City of Sumner **DESIGN COMMISSION**

AGENDA
Wednesday, February
21, 2024
6:30 p.m.

**a) 15403/15407 Main
Street**

DR-2023-0015 – Design Review for a
new commercial building to replace
one lost to a fire. Development
includes new 16,200sf building and
site improvements to .13 acre site.

SHEET TITLE
CONCEPTUAL SITE PLAN
FOR DESIGN REVIEW

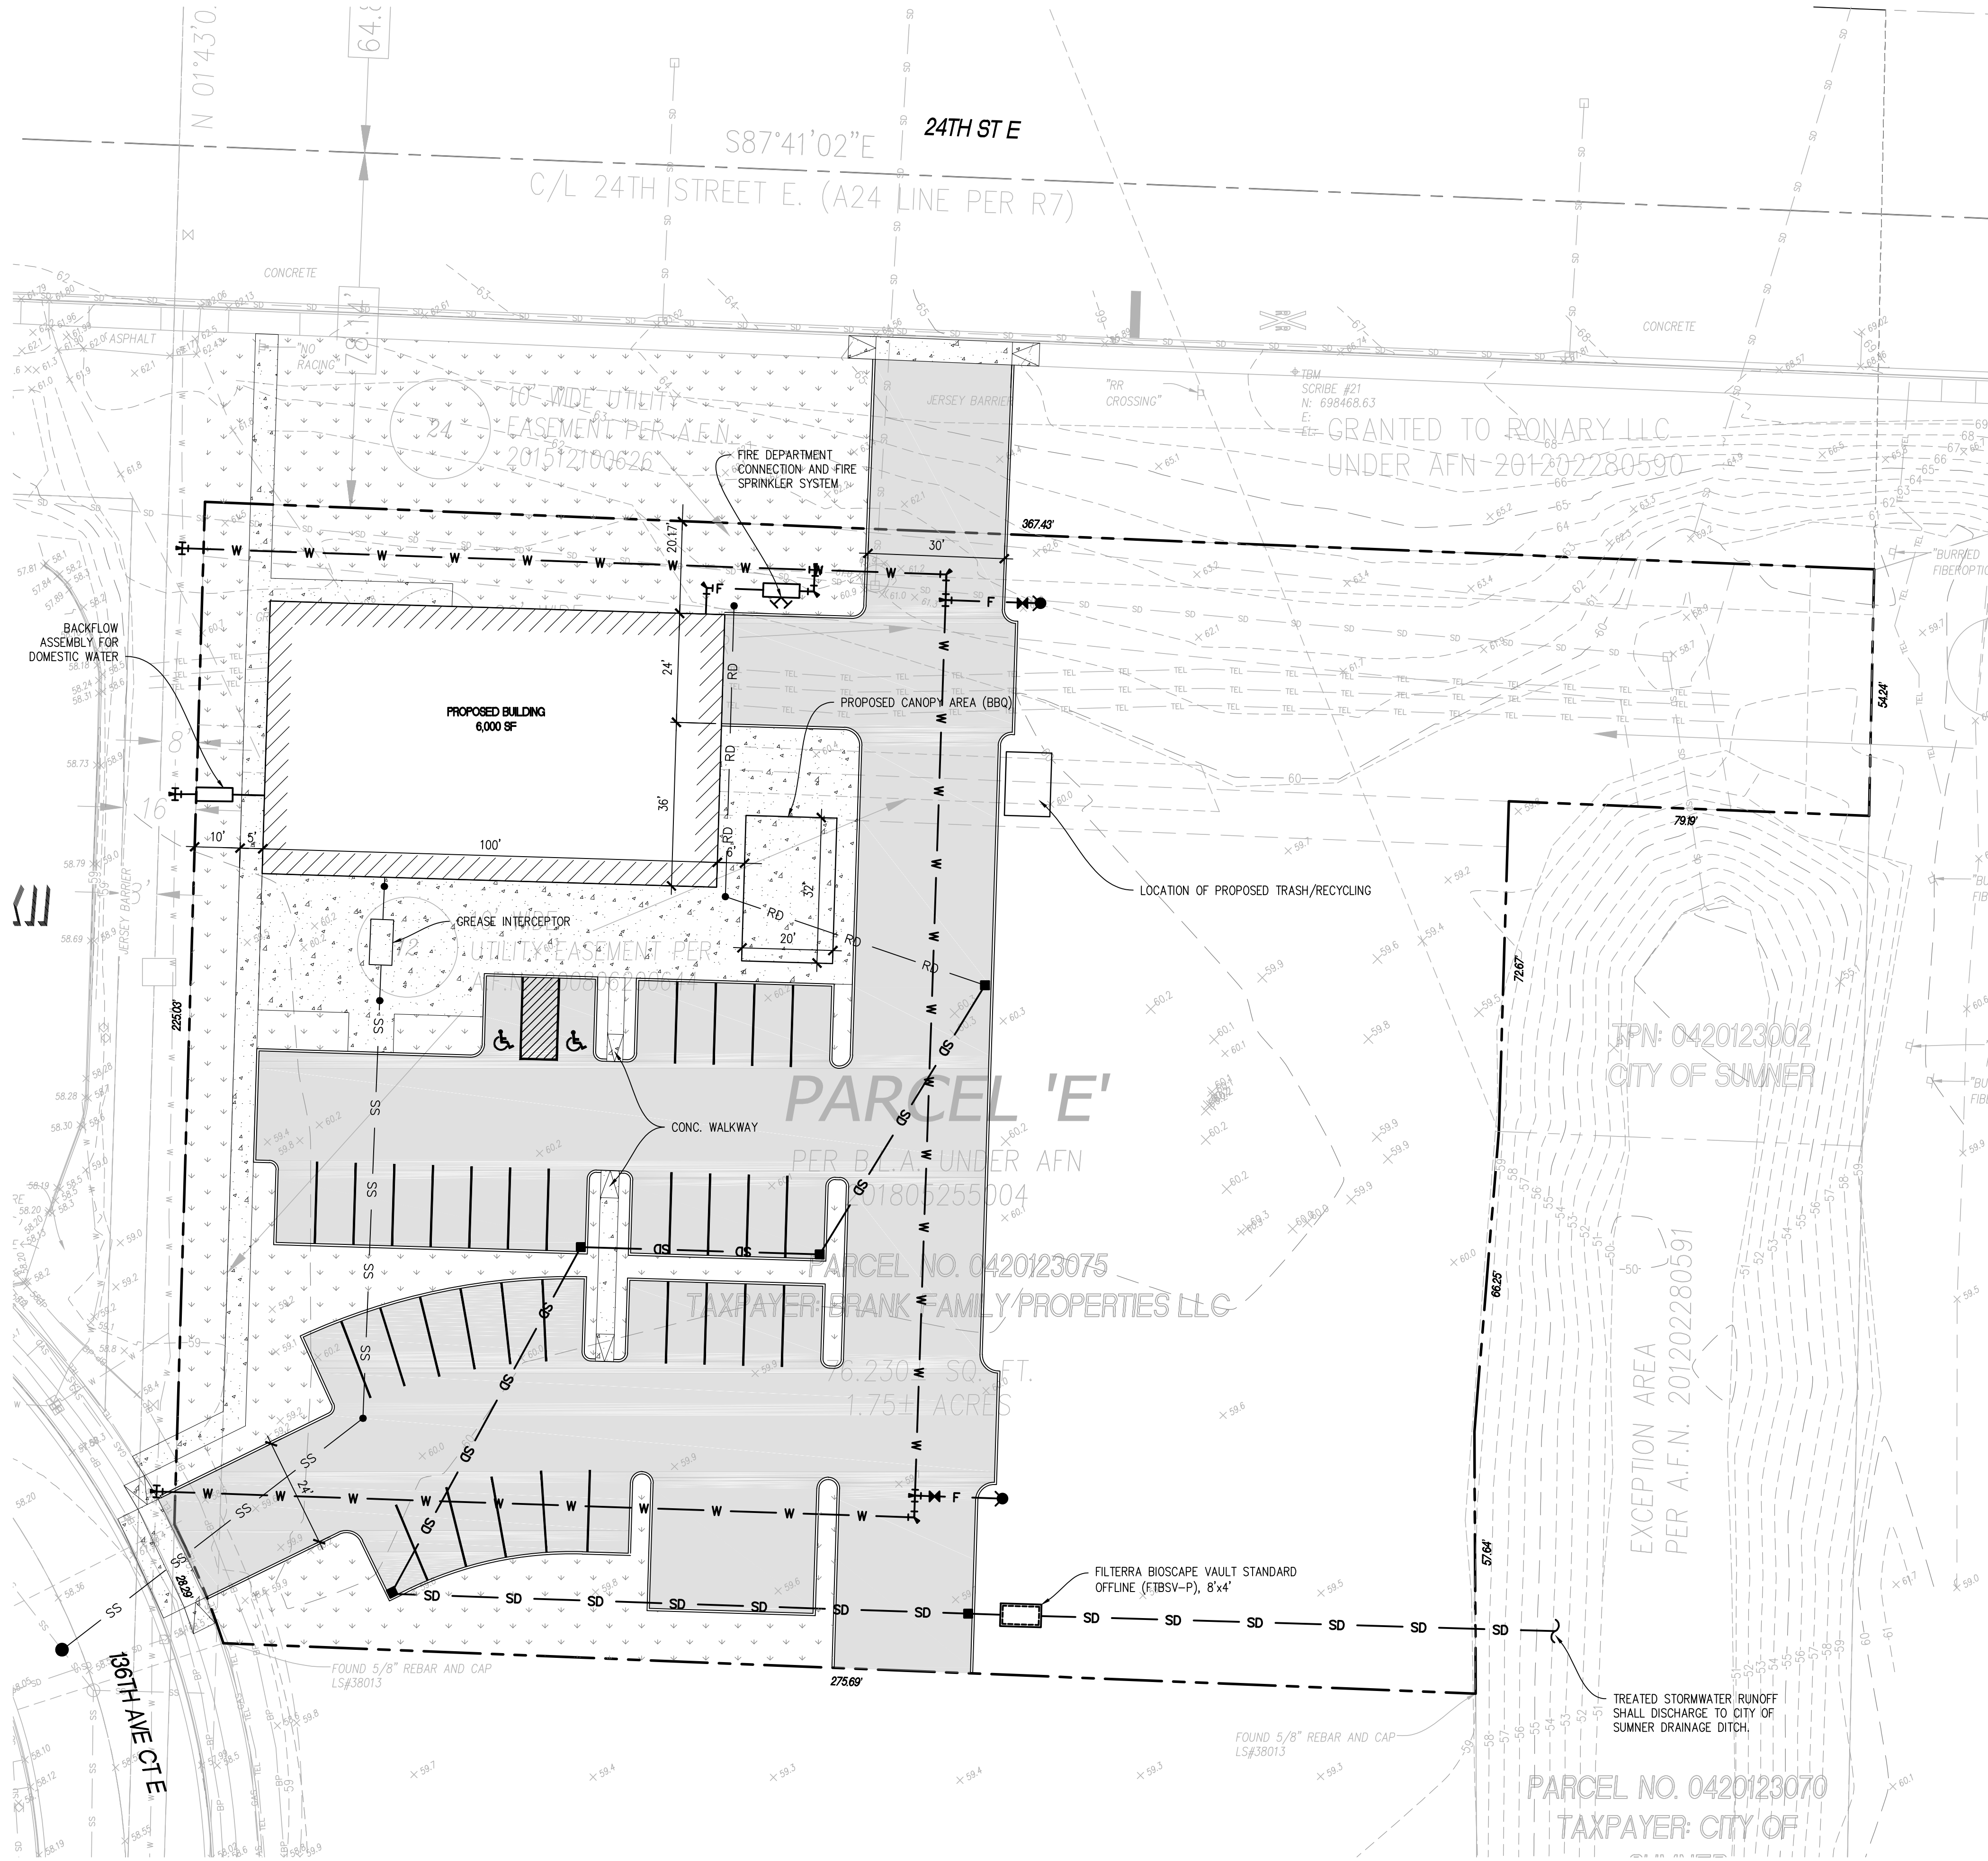
Provide an east west connection from the new Banks building pad to the eastern side of the property to connect it to the future development and a concrete connection through the parking lots connecting the south lot to the building.
3. **2.2.2 Weather protection**

Additional coverings should be included above the eastern entrances to provide weather protection and also provide another element to this visible façade.

4. **DG 2.2.5 Pedestrian Oriented Space**
 - A. Provide lighting in the concrete patio area (wall sconces, string lights or freestanding)
 - B. Include an extension to the inground planter strip or raised planters along the more of the south side of the patio area to better screen it from the parking and seating.
